# Changes marked with ~~Strikethroughs~~ and **Bold**, *Italics*

## REACTOR COOLANT SYSTEM

FARLEY - UNIT 1

Unit 1 Technical Specification Pages

FIGURE 3.4-1

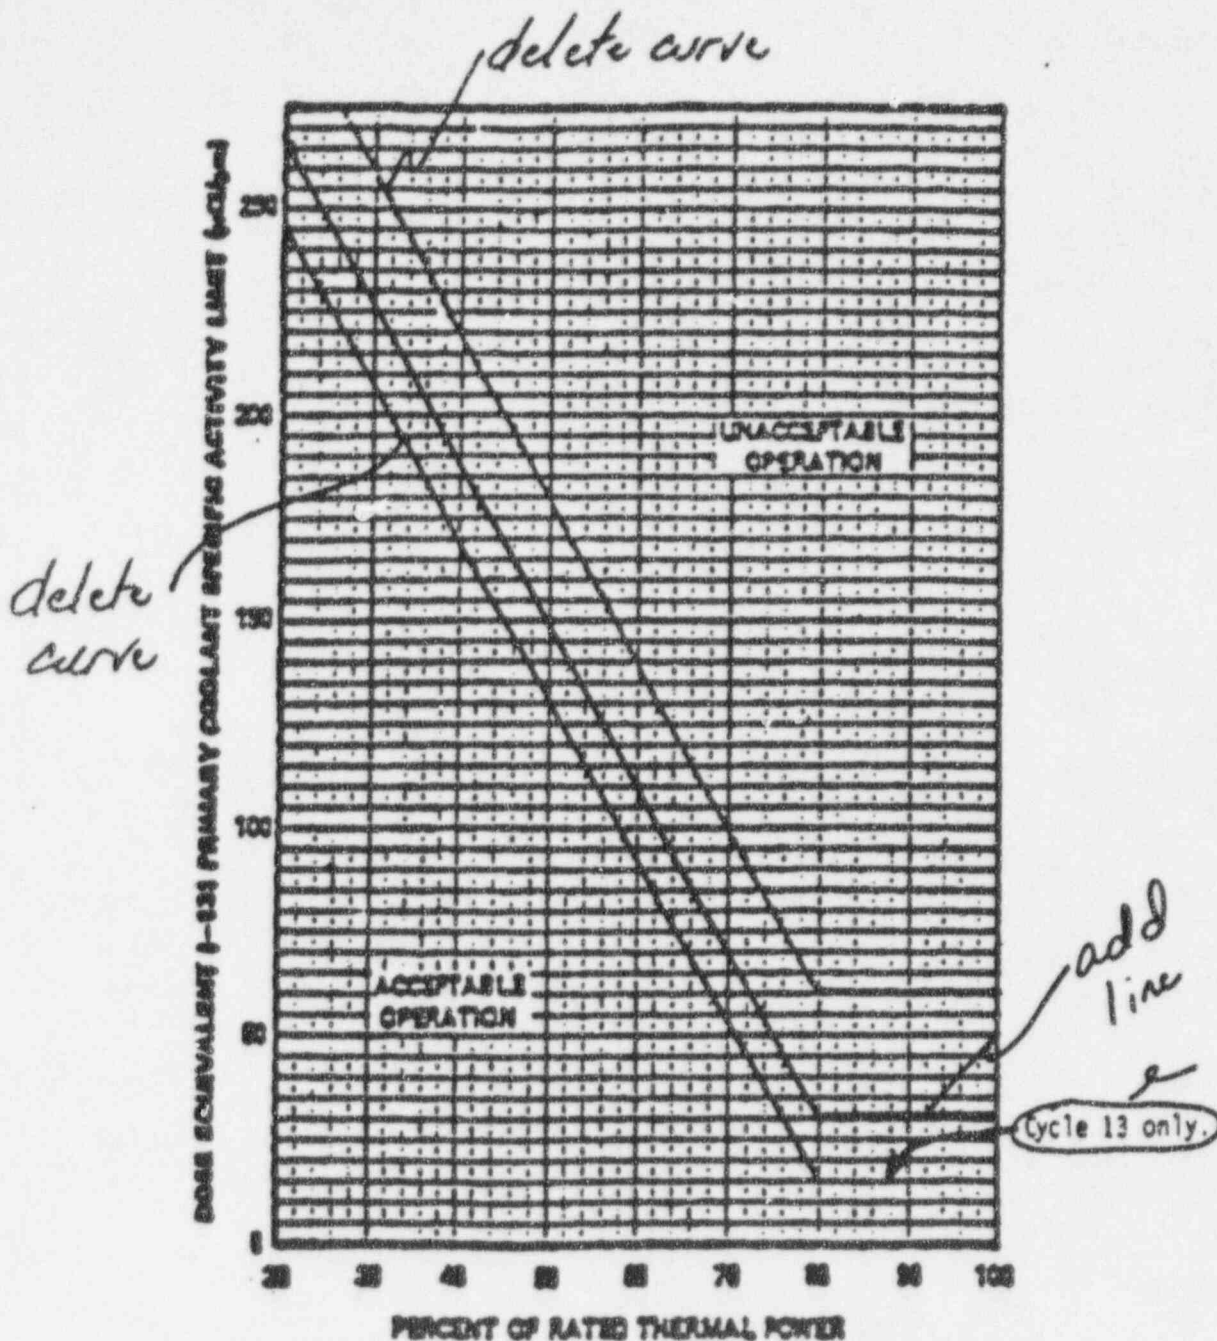
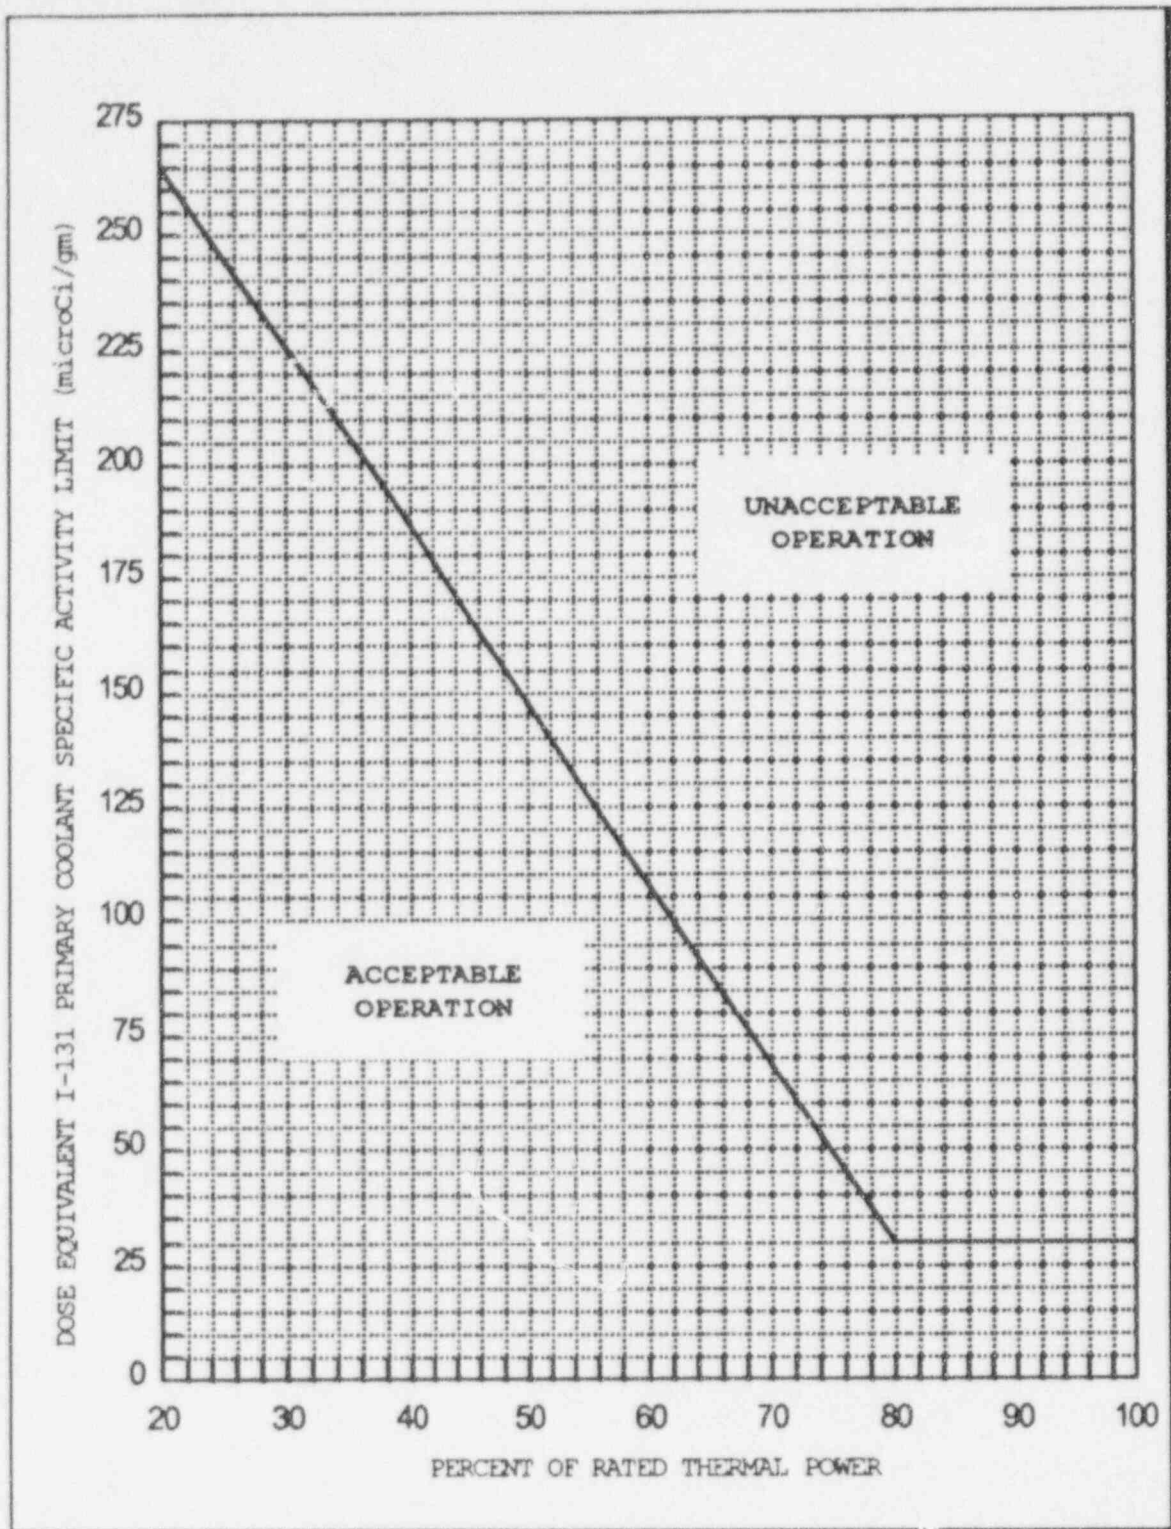
- a. ~~For the Thirteenth Operating Cycle only, with the specific activity of the primary coolant greater than 0.25 microCurie per gram DOSE EQUIVALENT I-131 for more than 48 hours during one continuous time interval or exceeding the limit line shown on Figure 3.4-1, be in at least HOT STANDBY with T<sub>avg</sub> less than 500°F within 6 hours.~~
- b.a. ~~For subsequent cycles, w~~**With** the specific activity of the primary coolant greater than ~~1.0~~ **0.5** microCurie per gram DOSE EQUIVALENT I-131 for more than 48 hours during one continuous time interval or exceeding the limit line shown on Figure 3.4-1, be in at least HOT STANDBY with T<sub>avg</sub> less than 500°F within 6 hours.
- e.b. With the specific activity of the primary coolant greater than 100/E microCurie per gram, be in at least HOT STANDBY with T<sub>avg</sub> less than 500°F within 6 hours.

(Activity  $> .25 \mu\text{Ci}/\text{gram}$  Dose Equivalent I-131 for Cycle 13 only.)

- a. With the specific activity of the primary coolant greater than 0.5 microCurie per gram DOSE EQUIVALENT I-131 for more than 48 hours during one continuous time interval or exceeding the limit line shown on Figure 3.4-1, be in at least HOT STANDBY with  $T_{avg}$  less than 500°F within 6 hours.
- b. With the specific activity of the primary coolant greater than  $100/\bar{E}$  microCurie per gram, be in at least HOT STANDBY with  $T_{avg}$  less than 500°F within 6 hours.

The ACTION statement permitting POWER OPERATION to continue for limited time periods with the primary coolant's specific activity greater than 0.5 microCuries/gram DOSE EQUIVALENT I-131, but within the allowable limit shown on Figure 3.4-1, accommodates possible iodine spiking phenomenon which may occur following changes in THERMAL POWER.
